《半山區東部分區計劃大綱草圖編號 S/H12/13》
Draft Mid-Levels East Outline Zoning Plan No. S/H12/13

申述人名單
Index of Representations

SCHEDULE OF AMENDMENTS TO
THE APPROVED MID-LEVELS EAST OUTLINE ZONING PLAN NO. S/H12/12
MADE BY THE TOWN PLANNING BOARD
UNDER THE TOWN PLANNING ORDINANCE (Chapter 131)

**Submission of Written Representation in respect of
Draft Mid-levels East Outline Zoning Plan No. S/H12/13**

Plan 4

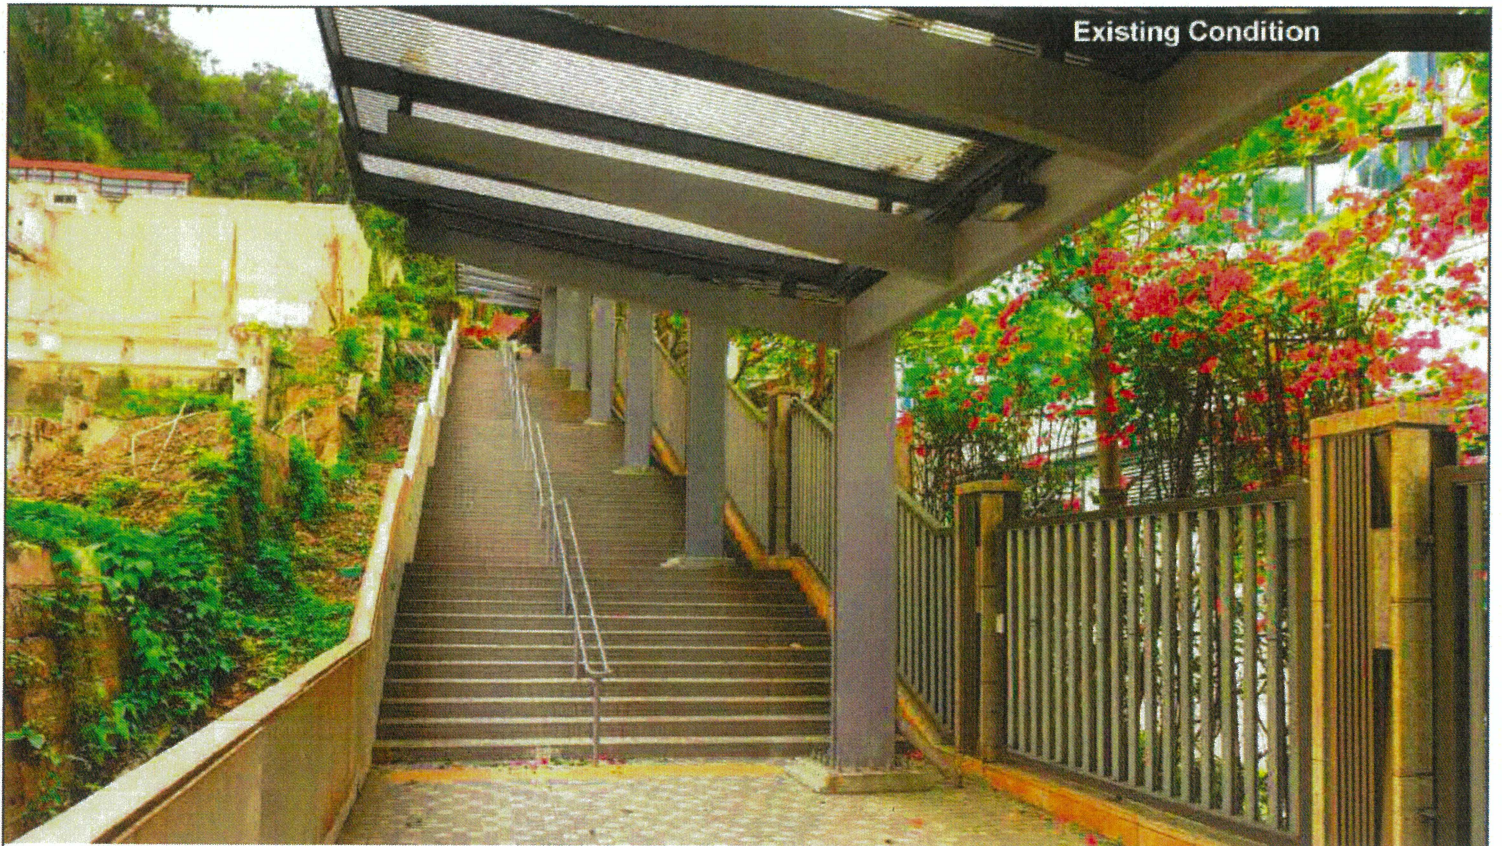
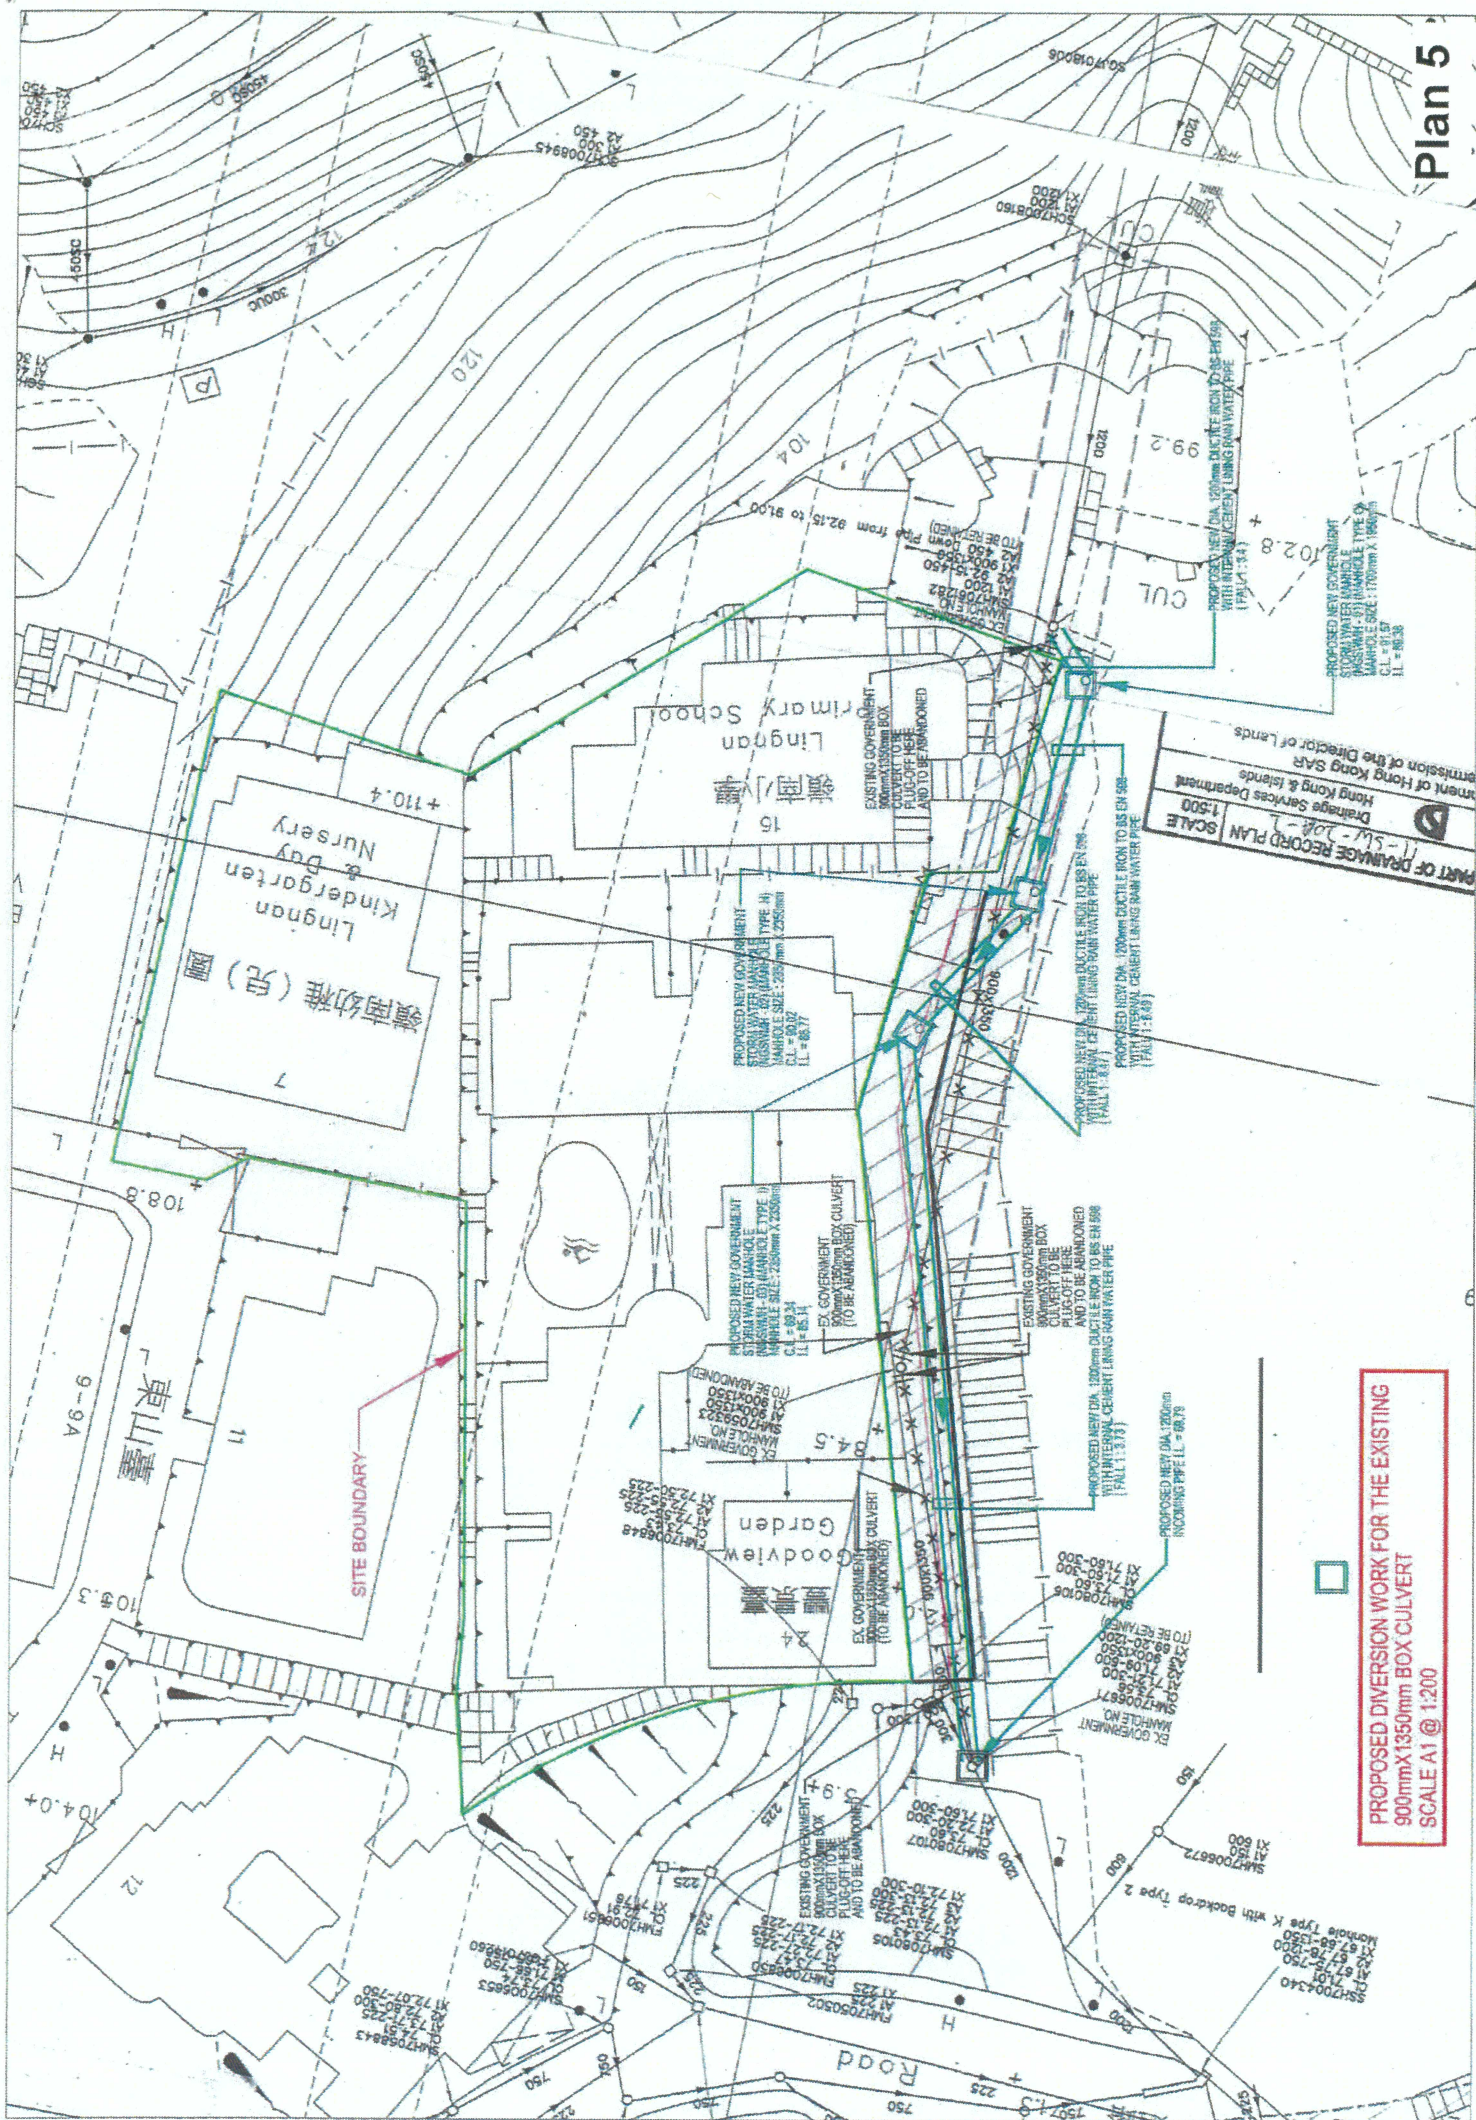
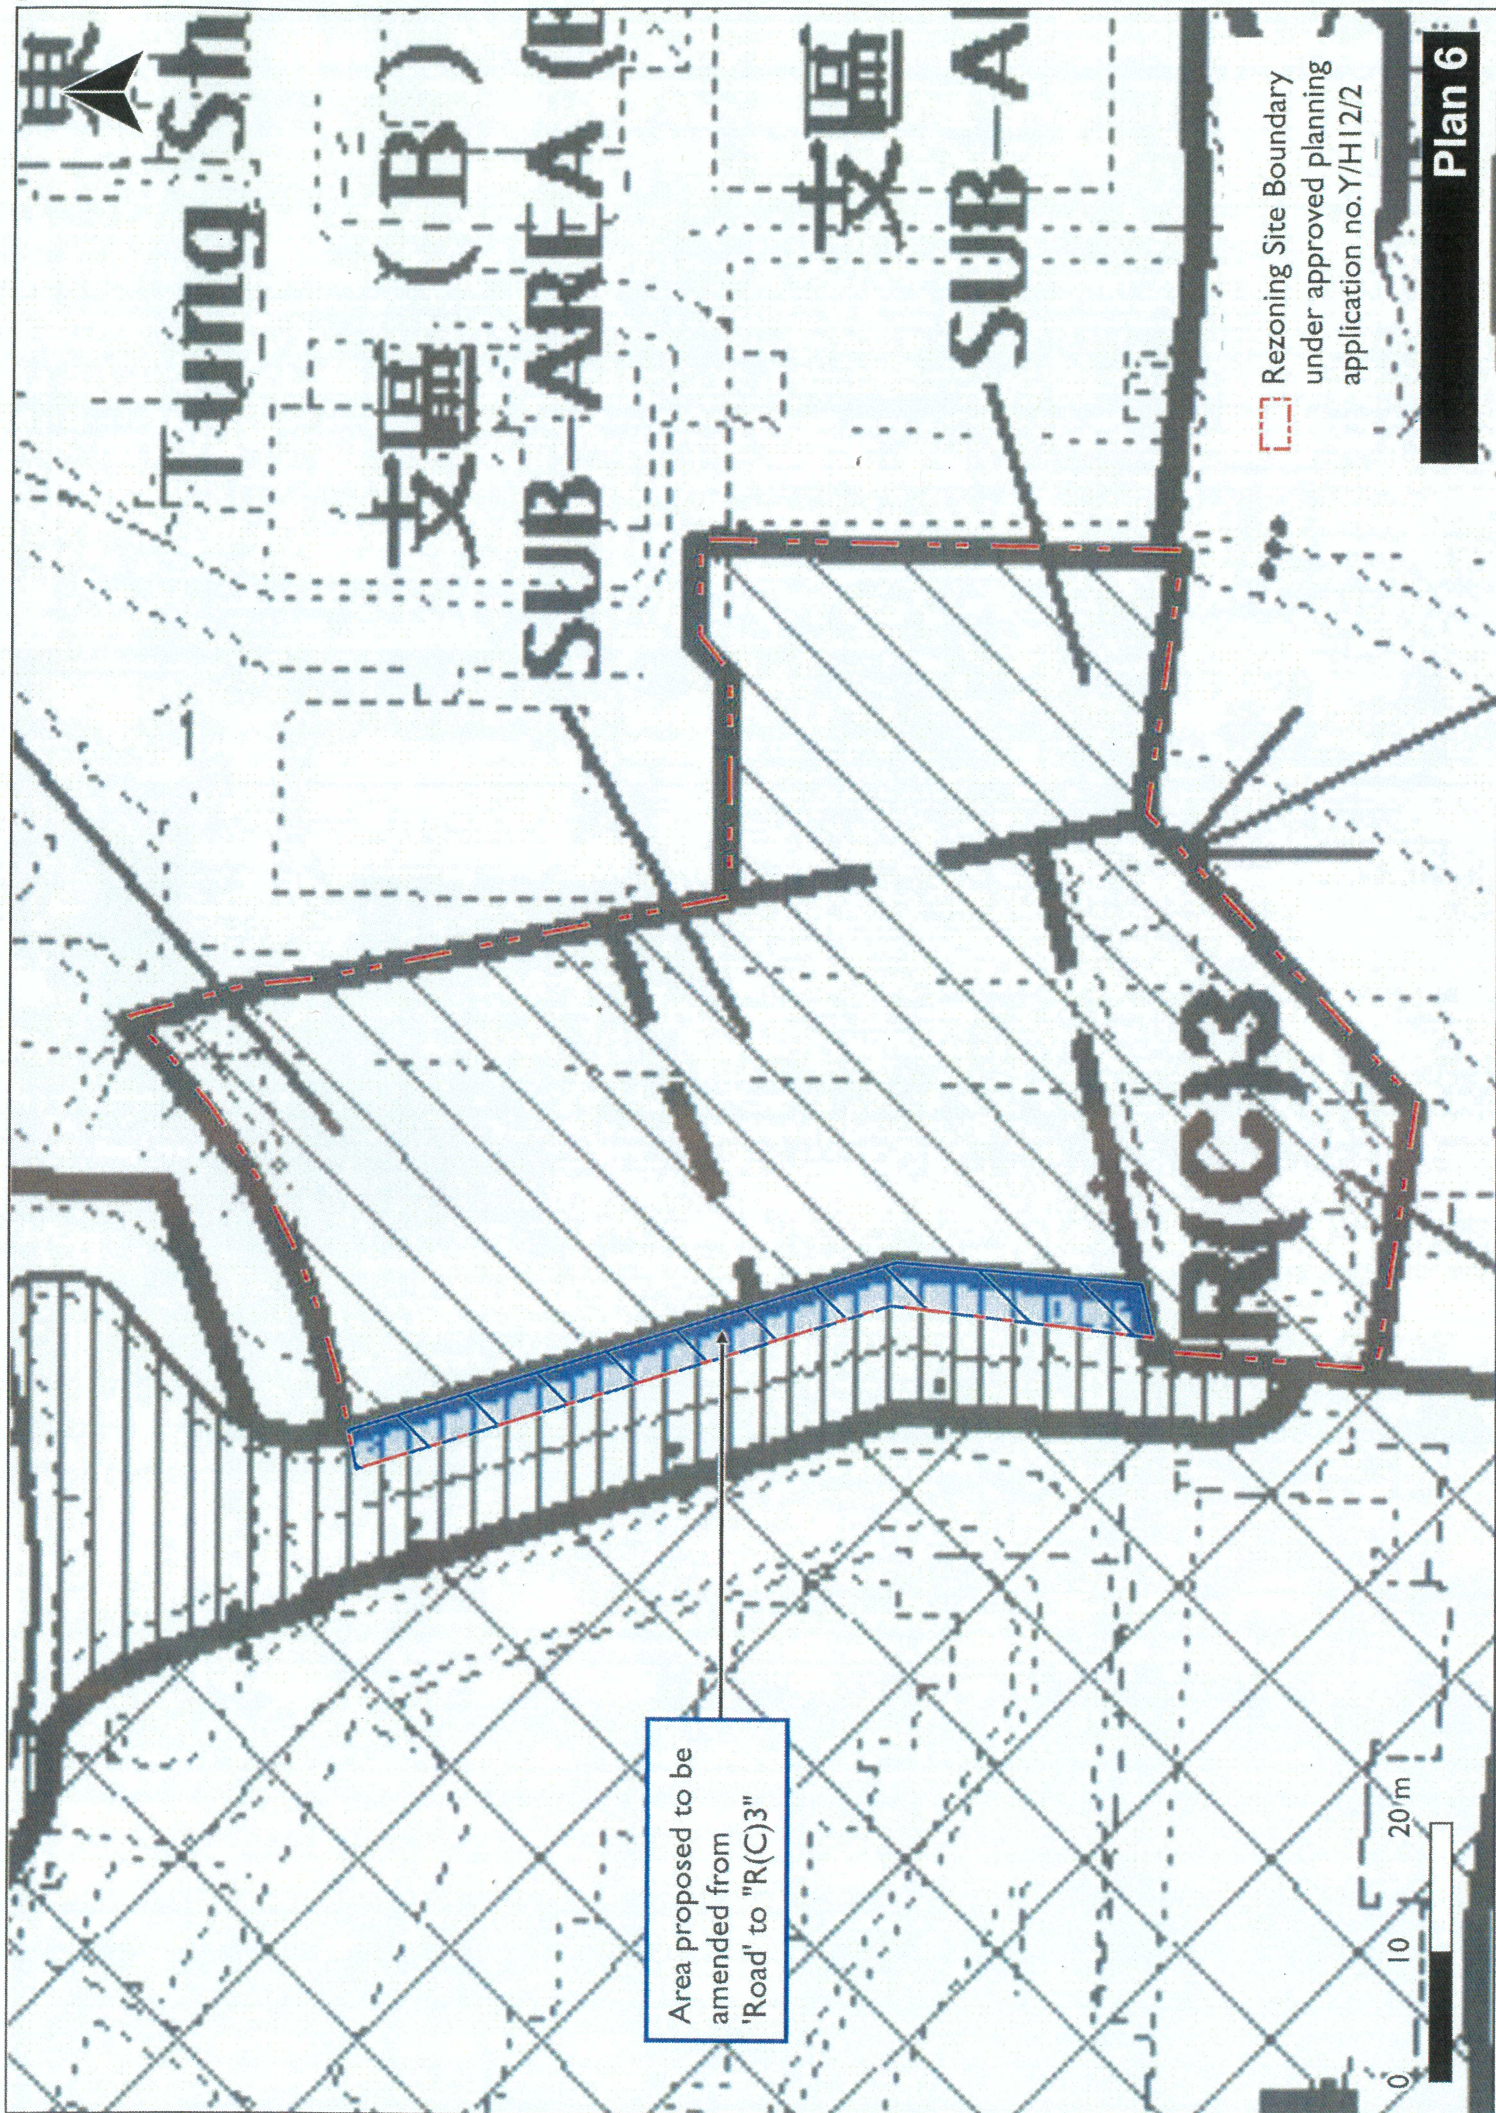
walkway, an on-street car parking space (maintained and managed by the Highways Department ("HyD")), an open "u" drainage channel (managed by Drainage Services Department ("DSD")), a retaining structure (Slope No. 11SW-D/R1233) (which is currently under the maintenance responsibility of the Representer (i.e. Landowner of Lot No. IL8371) (**Plan 1** refers)) and an area included in Representer's previous rezoning proposal to "R(C)3" zone as a non-building area ("NBA") (**Plan 2** refers). Part of the strip of Government land also falls within the drainage reserve area ("DRA") for the underground 900mm X 1350mm box culvert. At present, the concerned NBA is "No-Man's-Land" overgrown with vegetation without any proper maintenance which also cause concerns on public hygiene and safety (**Plan 3** refers).

It has always been the Representer's intention to bring about enhancement to NBA (which was also all along the area zoned "R(C)1" in the OZPs) in the previous rezoning proposal. As the maintenance agent of the retaining structure abutting the NBA, the Representer would like to take the opportunity to enhance the townscape and amenity of the locality by implementing landscaping treatment (i.e. lawn and shrub planting) at the NBA including the retaining structure to create a more biophilic environment that is coherent with the naturalistic environment of the surrounding context at her own cost. The enhancement proposal will complement the boundary landscape treatment of Central Peak with the creation of a desirable pedestrian walking environment with landscaping along both sides of the public staircase (**Plan 4** refers).

To enable the above townscape enhancement proposal which will bring about long term environmental improvement to the area, the Representer sincerely requests the TPB to amend the concerned strip of Government land from area shown as 'Road' back to "R(C)3" zone as originally proposed under the S12A Planning Application. This will allow the Representer to proceed with the subsequent land procedure for the implementation of the proposal with the designation of coloured area such as "Pink Cross Hatched Black Area" on the lease for better management and maintenance by the Representer. The proposal will also enhance safety and security by bringing improvement to the current "No Man's Land" which is currently without any proper maintenance and management. This arrangement is similar to that of the adjacent development, Central Peak, in which the part of the lot falling within DRA was designated as Pink Cross Hatched Black Area and is used as a landscape area (as indicated on the approved Building Plan). In fact, it is not uncommon that the DRA falls within the Site.

- Revisit and rationalize the boundary of the area shown as 'Road' to include the NBA in the "R(C)3" zone to facilitate the Representer's proposal to enhance the townscape and amenity of the locality as well as improvement to security and safety for the public (Plan 6 refers).

There are already serious traffic congestion along Stubbs Road and Queen's Road East during the peak periods

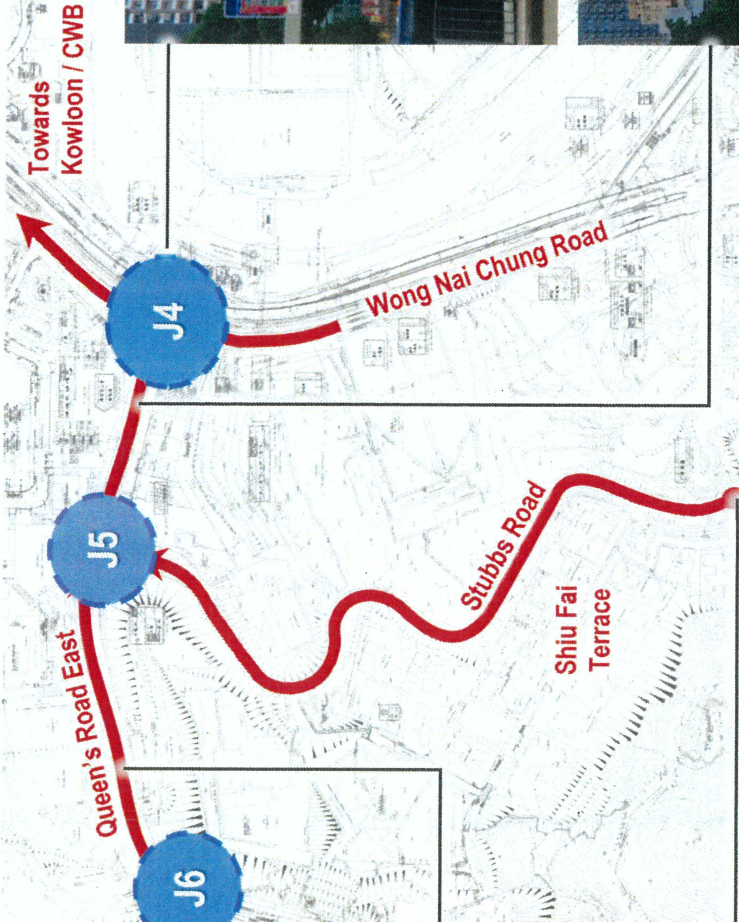
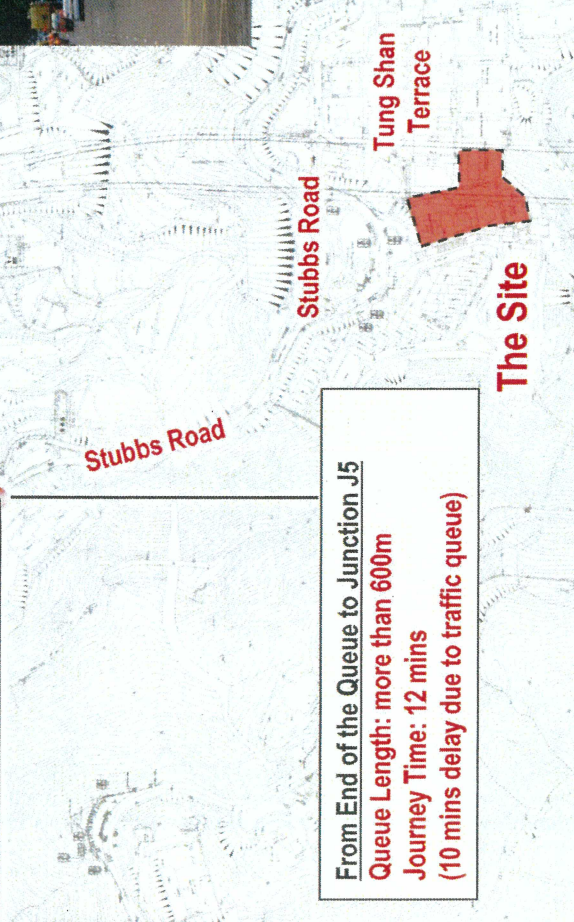
The associated implications to traffic would therefore be significant and have to be addressed in future submission (e.g. S16 planning application).

From End of the Queue to Junction J6
Queue Length: more than 400m
Journey Time: 7 mins
(5 mins delay due to traffic queue)

From End of the Queue to Junction J5
Queue Length: more than 600m
Journey Time: 12 mins
(10 mins delay due to traffic queue)

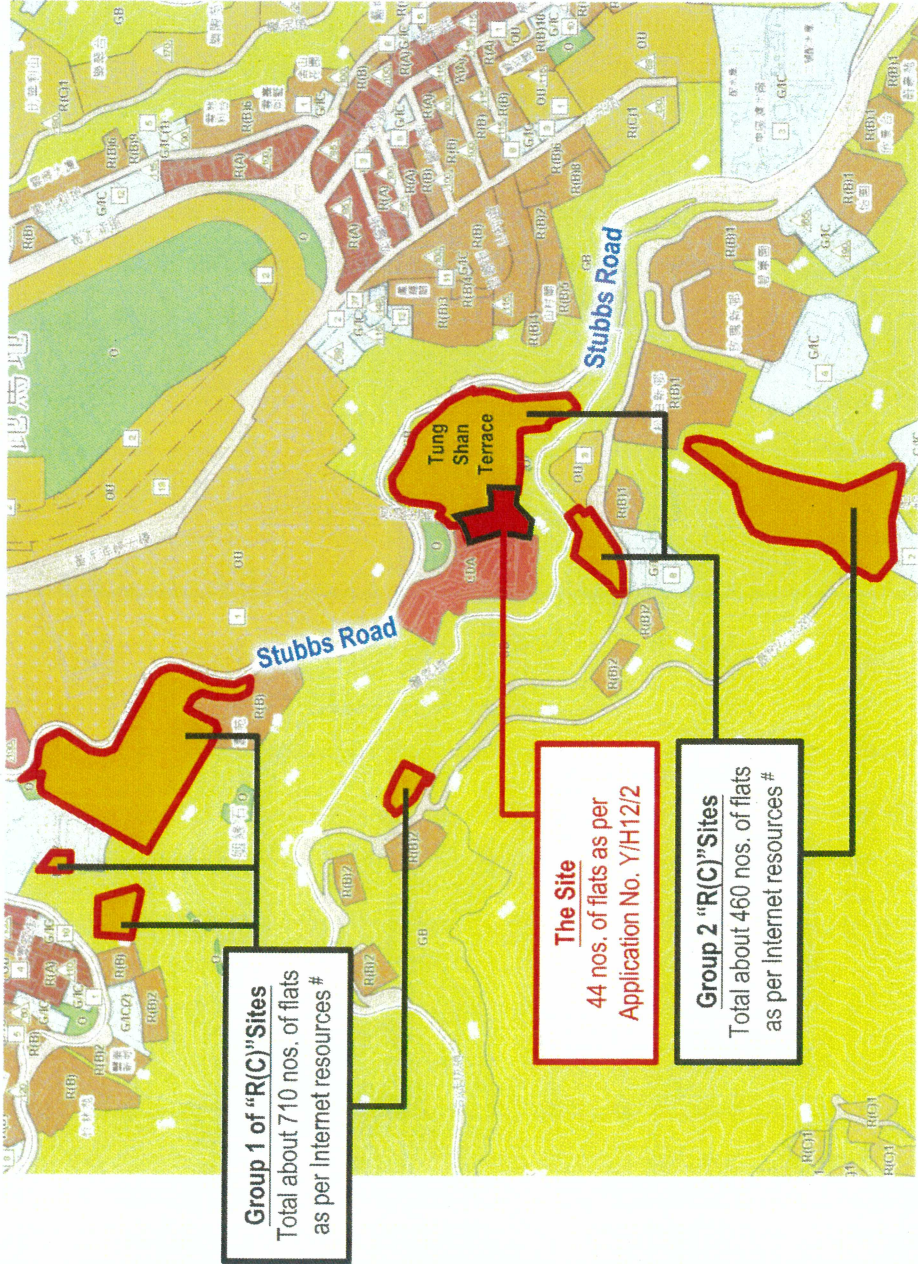
A number of "R(C)" sites are situated along Stubbs Road the approved S12A rezoning application site, which all vehicular traffic is highly reliant on Stubbs Road for access.

There will be substantial adverse cumulative traffic impacts on the surrounding road networks if all these nearby "R(C)" sites are up-zoned (see table below). Although each up-zoning proposal will require separate planning application for approval of the TPB, all possible up-zoning of development sites in relation to the Proposed Development should be included as sensitivity test to provide a full picture for TD's consideration as a usual practice. This has been requested by TD in S12A application stage but this has been ignored by the applicant.

Without mechanism to require the Applicant to submit further technical assessment, further design revision with increase in nos. of flats would lead to highly unstable traffic condition and could easily trigger widespread congestion and extensive long traffic queues in the surrounding neighbourhood, and leading to strong public complaints to relevant departments in future. The condition will be irreversible and would therefore worth thorough consideration of the TPB and relevant departments at this stage instead.
